**MEETING DATE:** November 6, 2023

**TOPIC:** PC-23-005 - Starboard Orion Site Plan Review #2

**BACKGROUND BRIEF:** Starboard Orion is a site plan request for a 12-unit multiple-family development at 10 S. Park Boulevard. The site contains three parcels (09-02-460-032, 09-02-460-033, & 09-02-460-036), southwest of the Flint Street and S. Park Boulevard (M-24) intersection. The Project scope includes:

Date:	08.05.2022
Scale:	1" = 20'
Sheet:	C7
Project:	20107.30

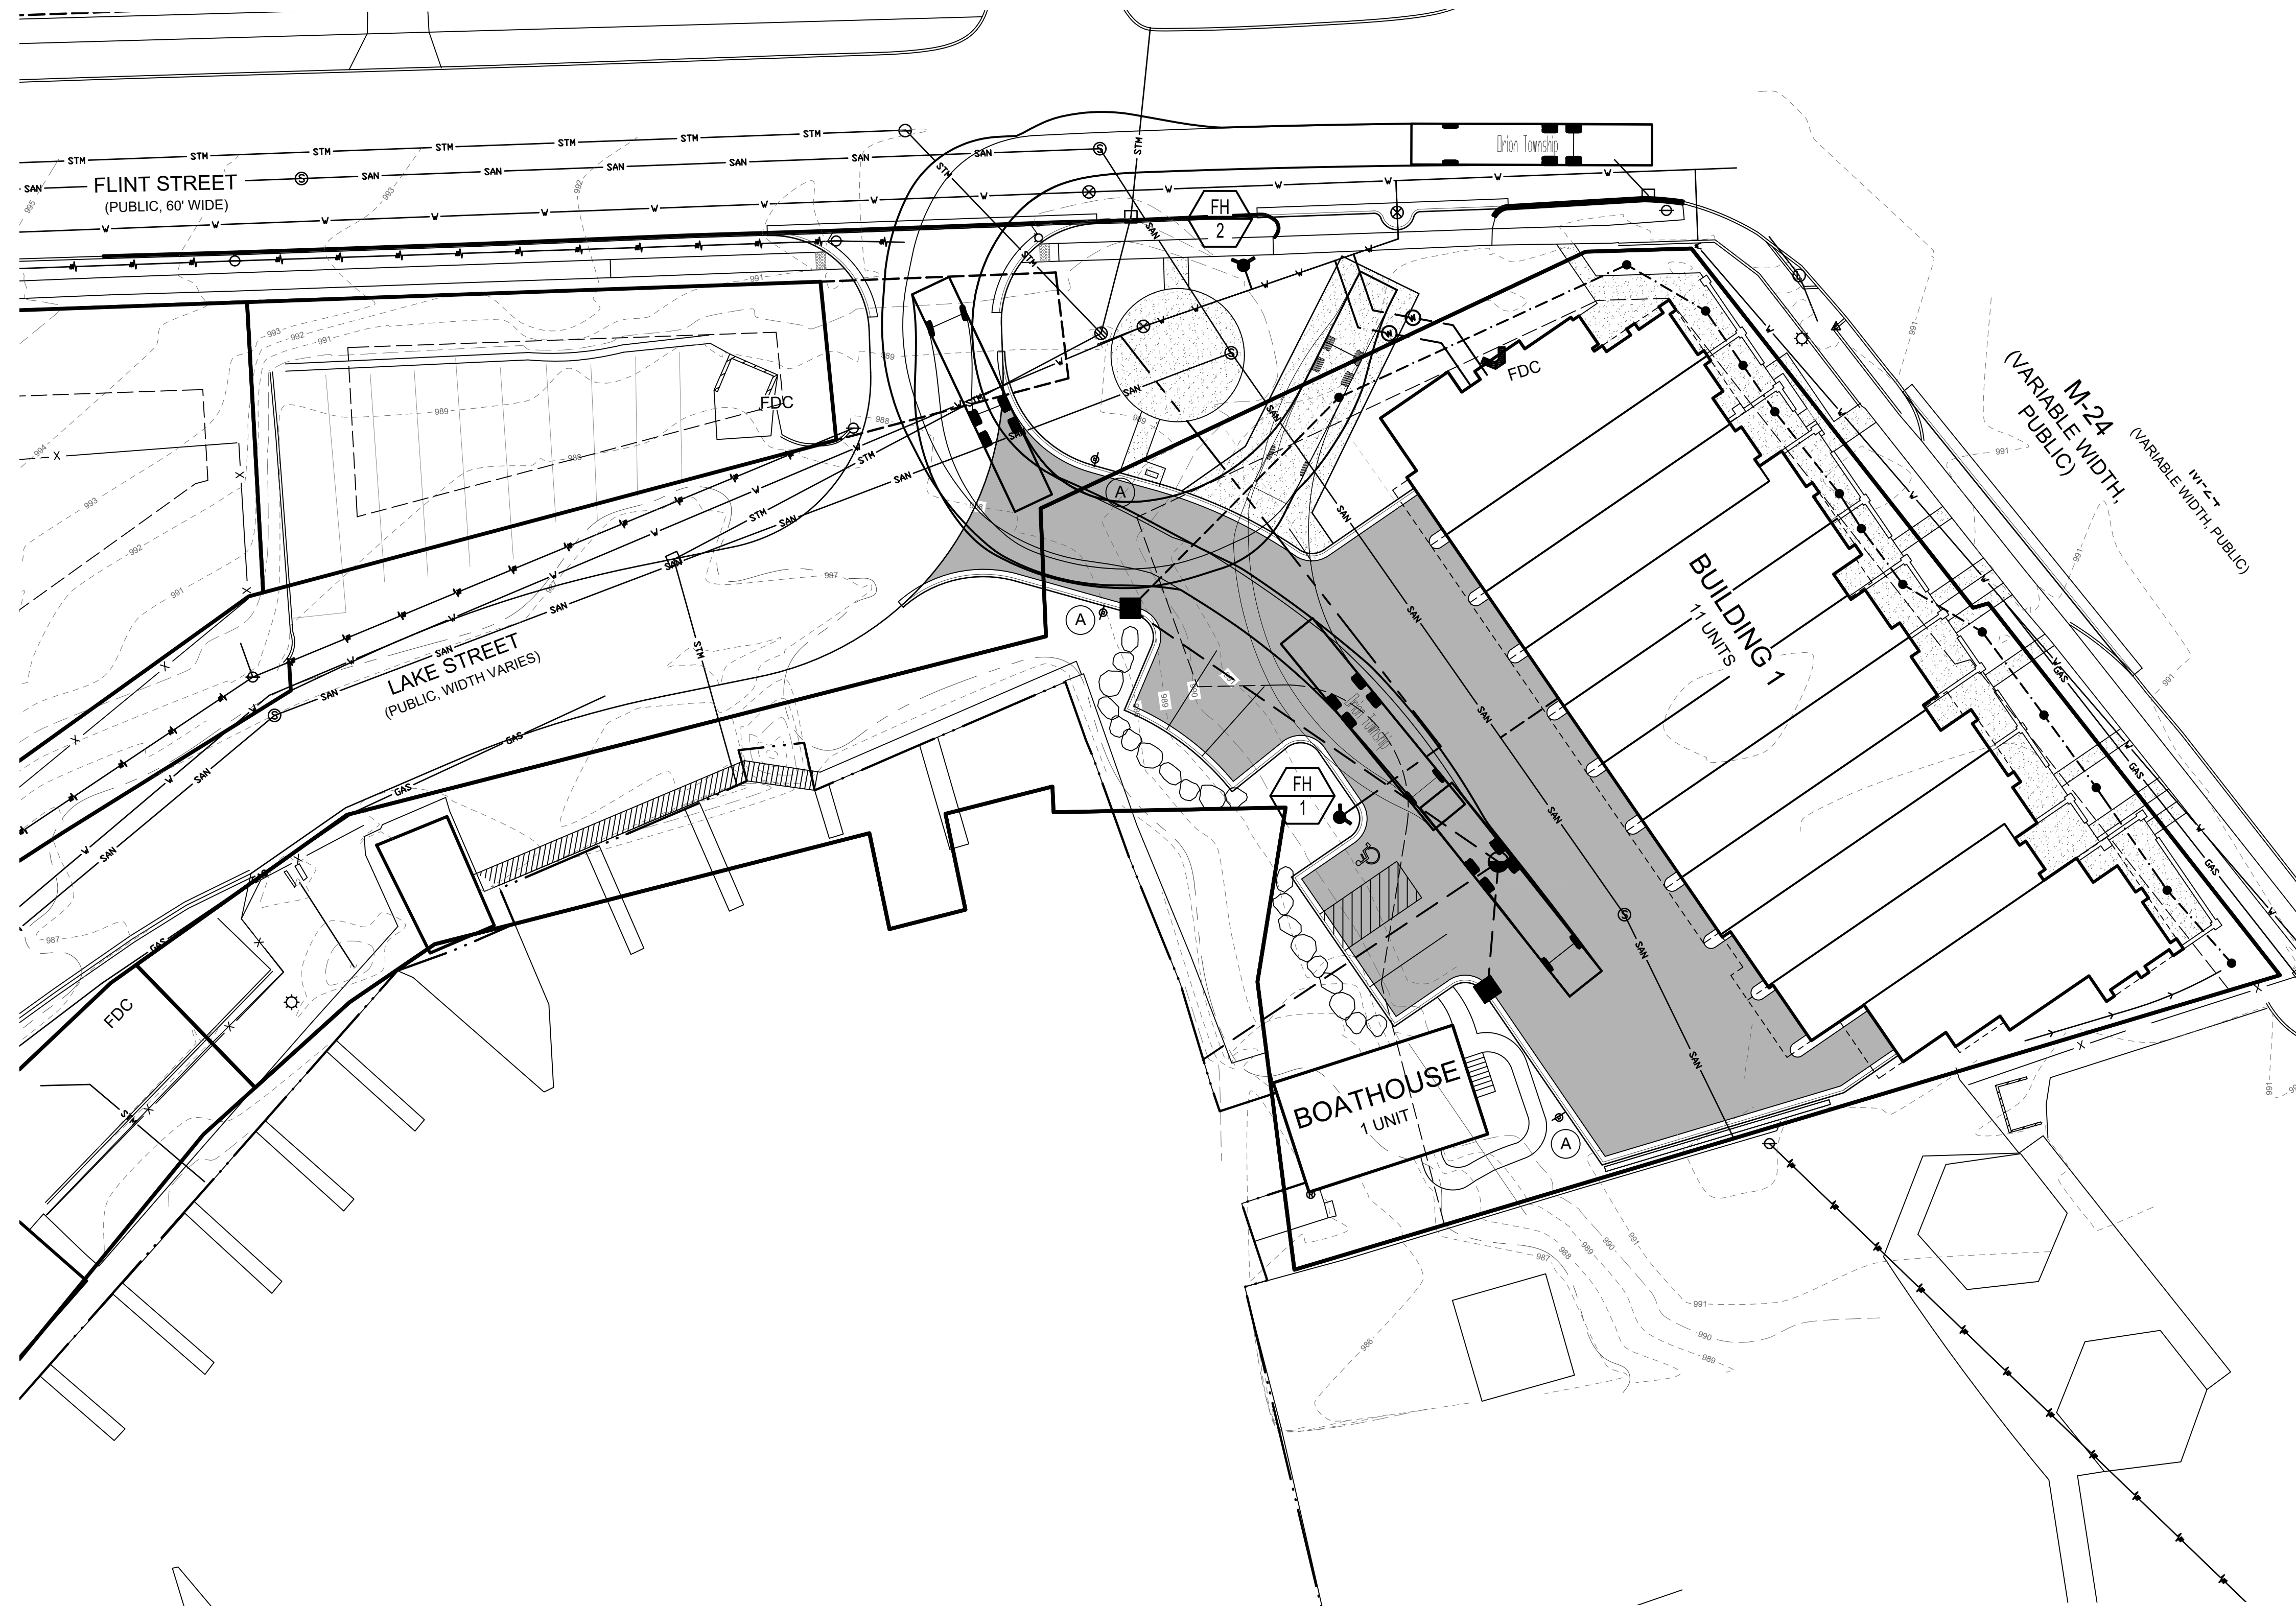
- Details for the No Parking Fire Lane signage including road striping (cross hatching) area shall be indicated on the plan. Please provide Fire Lane signage for the T-Turnaround located on site.
- Dimensions shall be provided for the proposed T-Turnaround showing compliance with International Fire Code Figure D103.1.

1. Details for the No Parking Fire Lane signage including road striping (cross hatching) area shall be indicated on the plan. Please provide Fire Lane signage for the T-Turnaround located on site.  
*Acknowledged.*
2. Dimensions shall be provided for the proposed T-Turnaround showing compliance with International Fire Code Figure D103.1.  
*Dimensions will be provided.*

Date:	08.05.2022
Scale:	1" = 20'
Sheet:	LA-100
Project:	20107.30

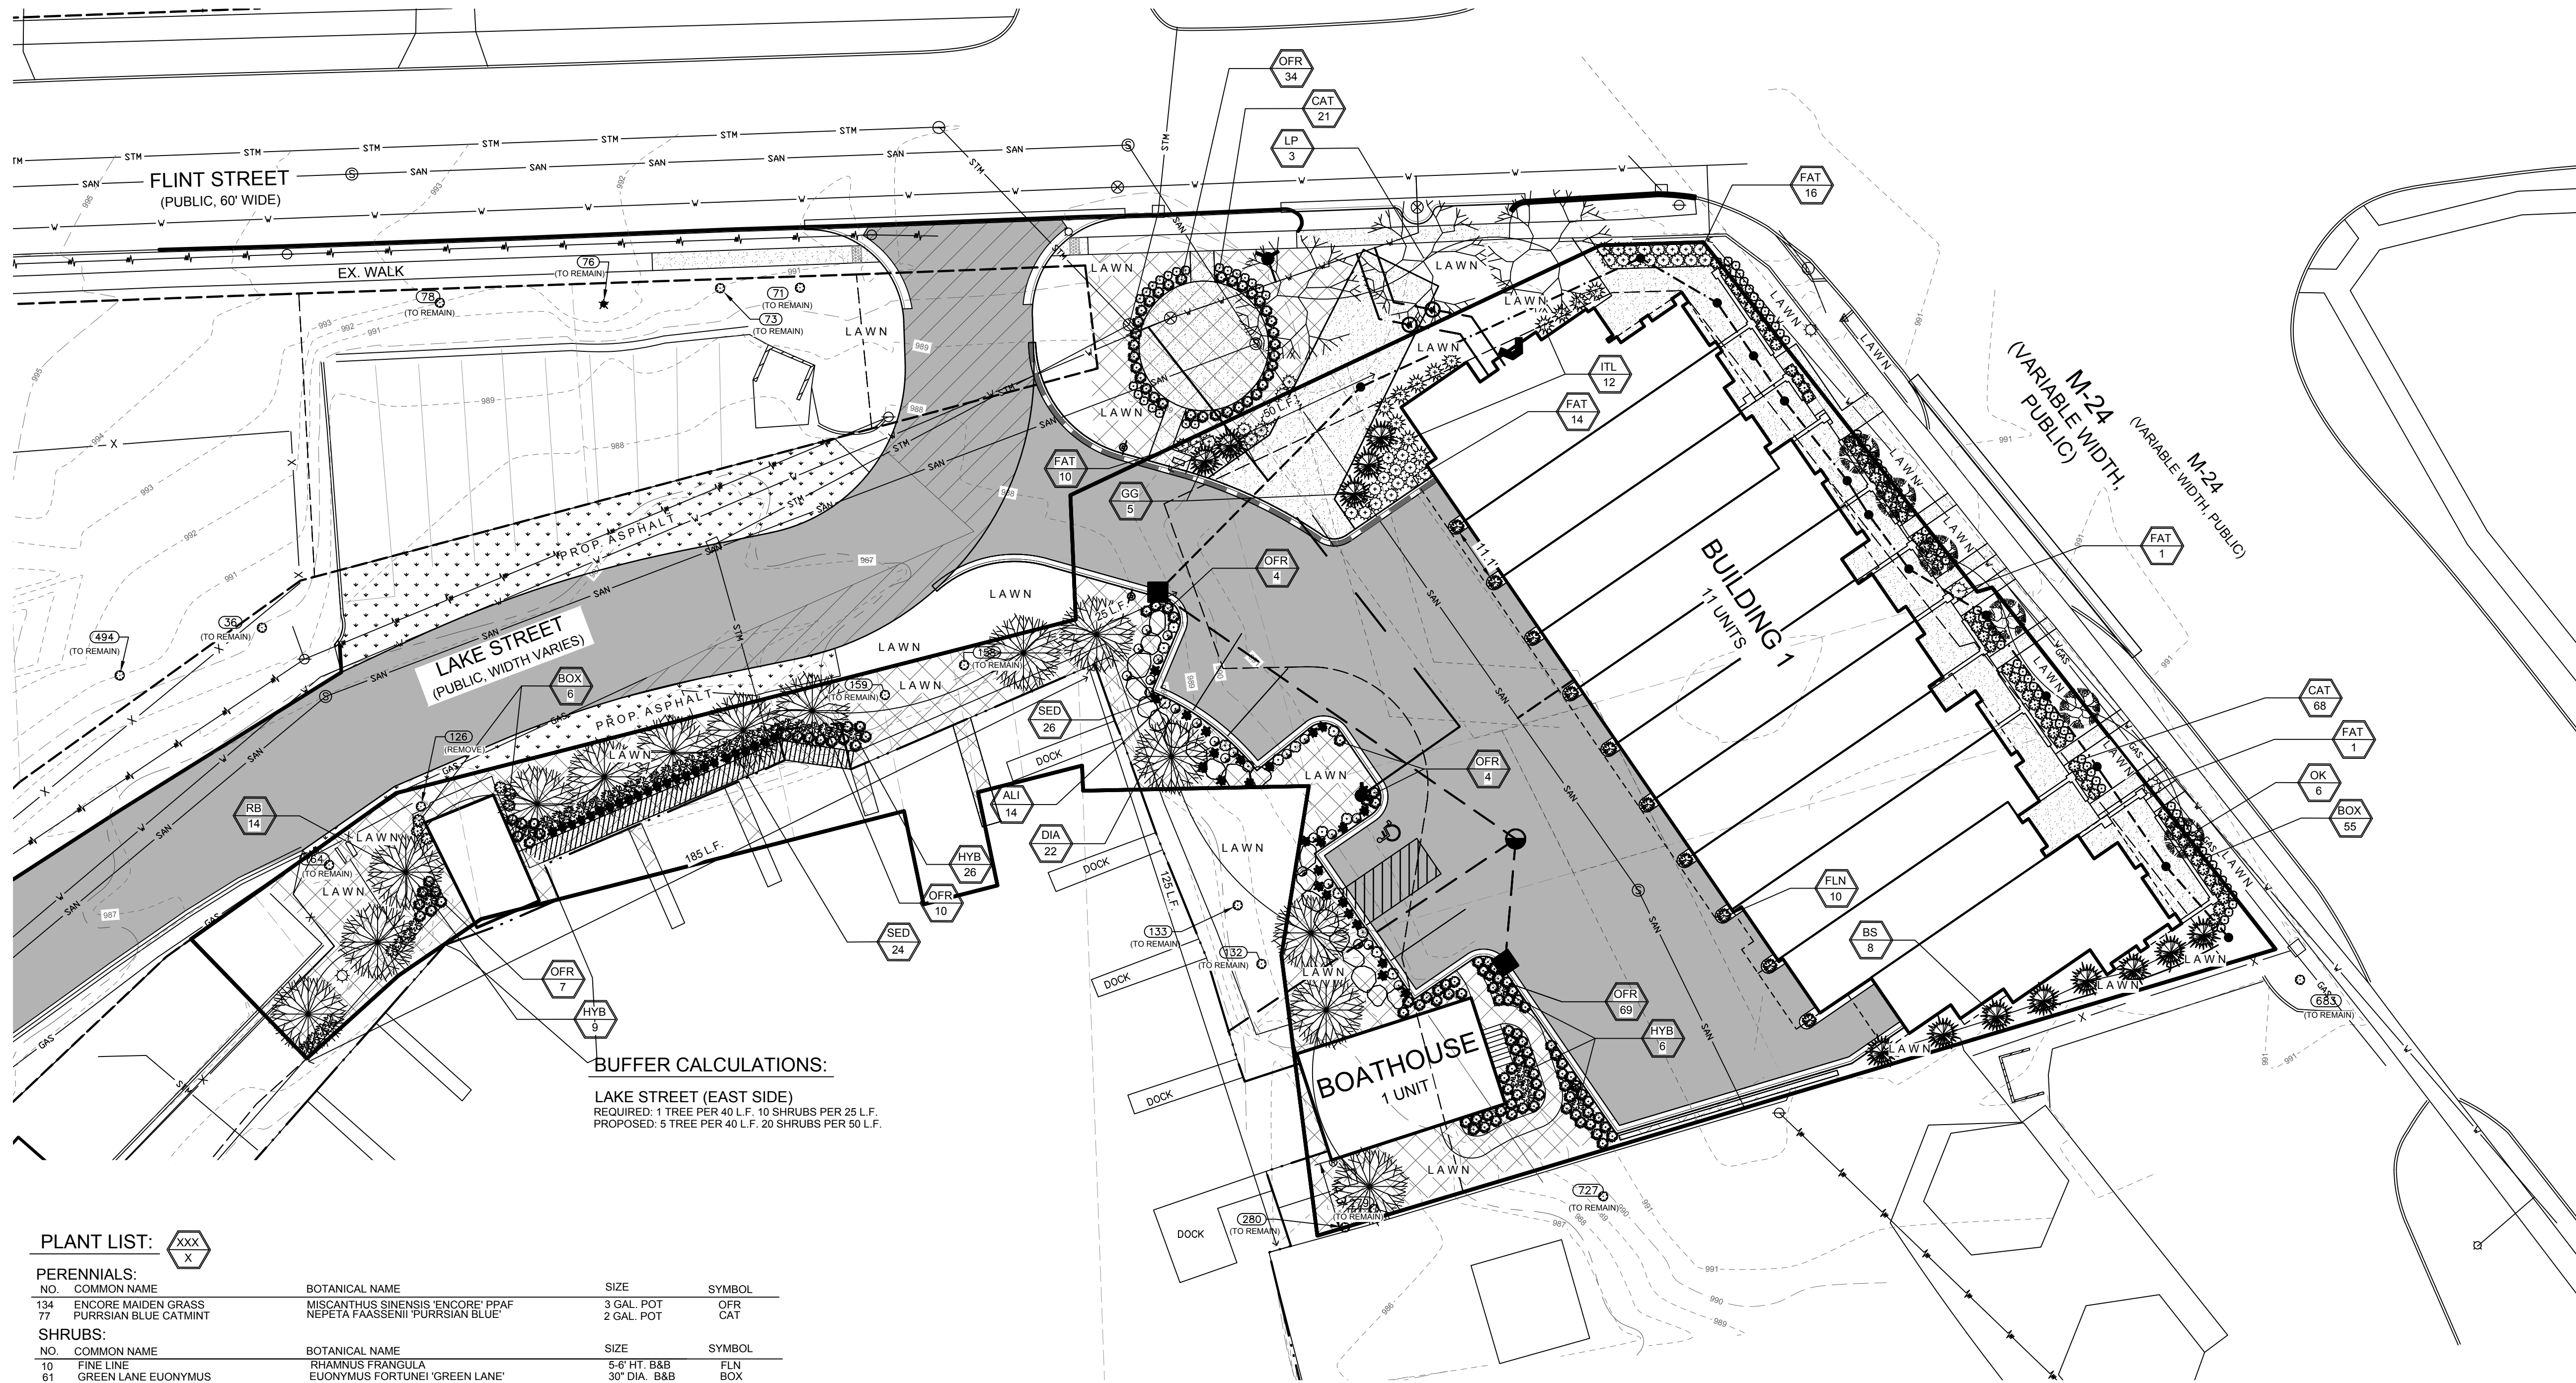
**Landscaping and Plant Material.** The applicant has provided a landscaping plan on sheets LA-100 and LA-101. The following landscaping and screening standards are relevant to this Project:

Sheet No: **1 OF 8**

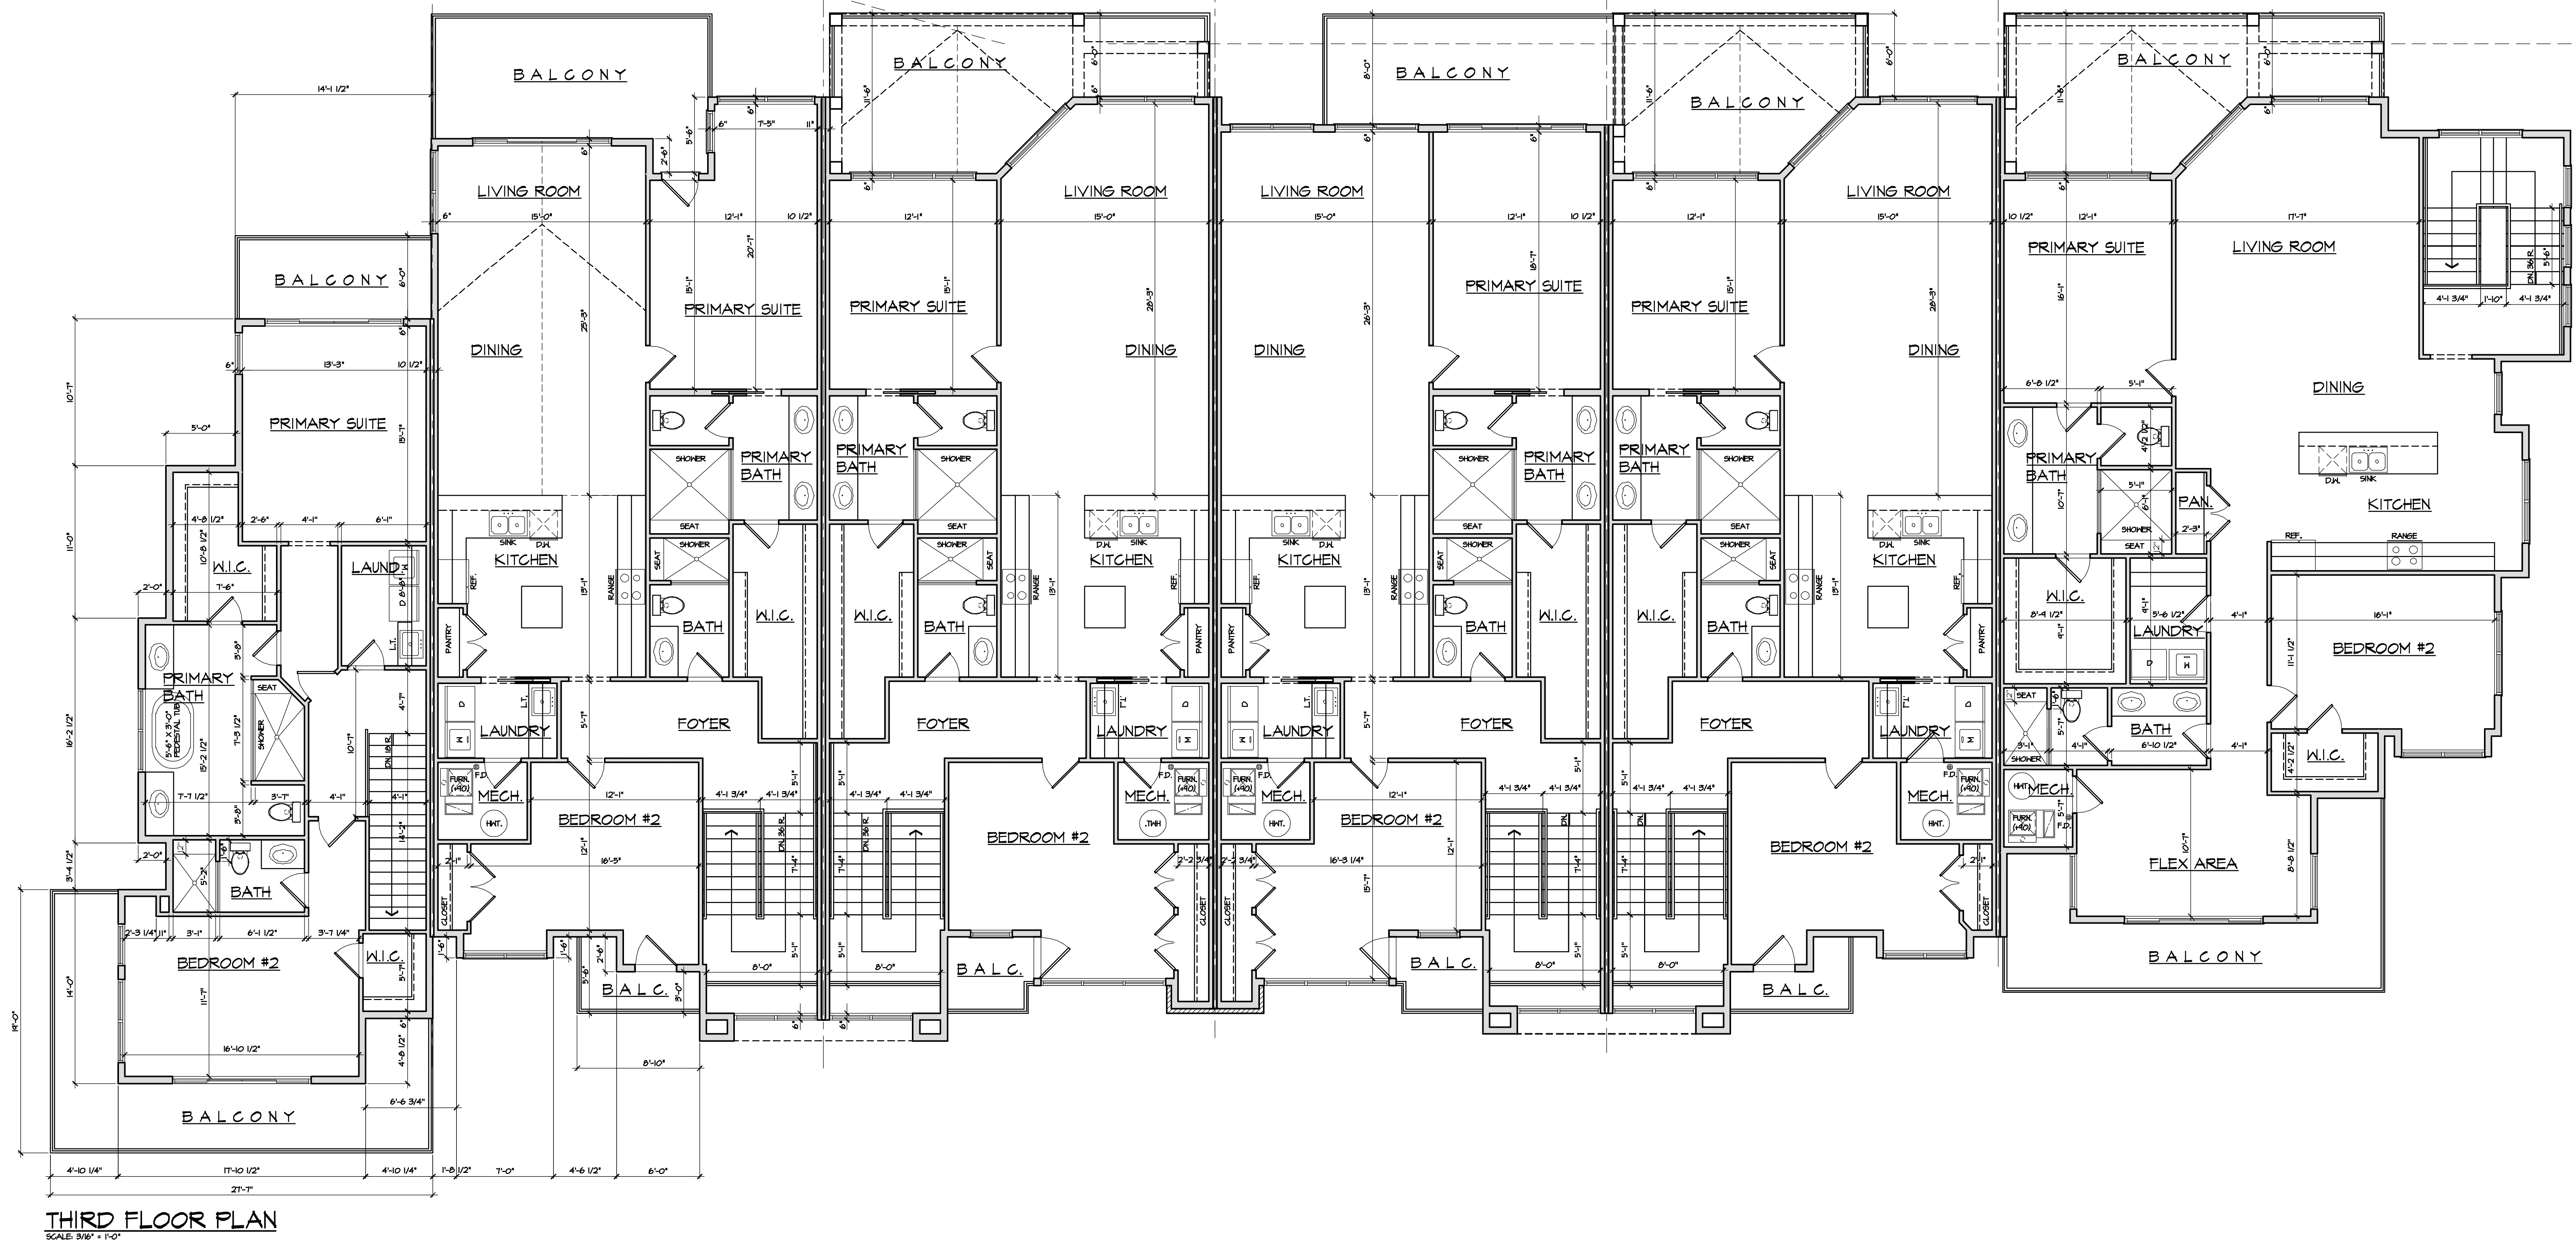
11. A "no parking" sign must be provided at unit that is second from the south end of the building. If a car is parked outside the garage, access is blocked to the southernmost unit. The floor plan provided (Sheet 1 of 8) is inconsistent with the parking spaces indicated on the site plan.
